Re: Addendum 1

Project ID: EB-5803 County: Catawba Bid Date: April 4, 2017

CONOVER DOWNTOWN

STREETSCAPE

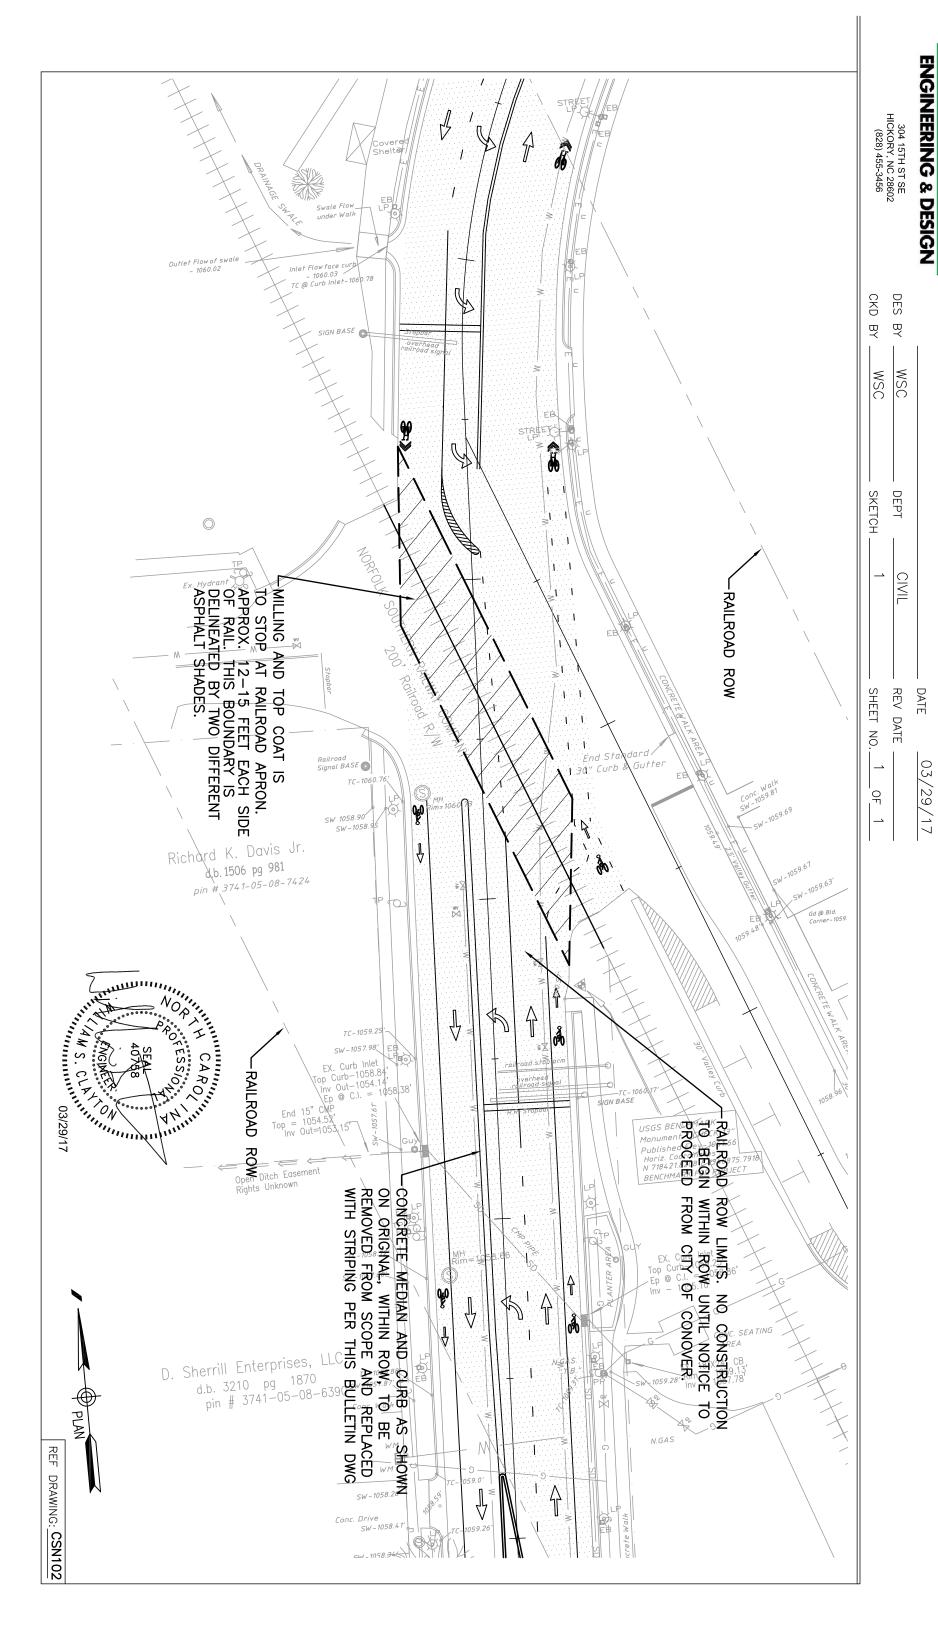
- 2.) Duration of work within the Railroad ROW is not to exceed 30 days.
- 3.) See bulletin drawing #1 (attached). Approximately 30 SY of concrete median and 100 LF of 9" curb to be removed from project scope and replaced with striping. The following line items on the bid form have been changed.

- a. Line item 8 9"x18" Concrete Curb quantity to 1,417 LF
 - b. Line item 9 Concrete Median quantity to 25 SY
 - c. Line item 18 Double Yellow Line quantity to 6,676 LF
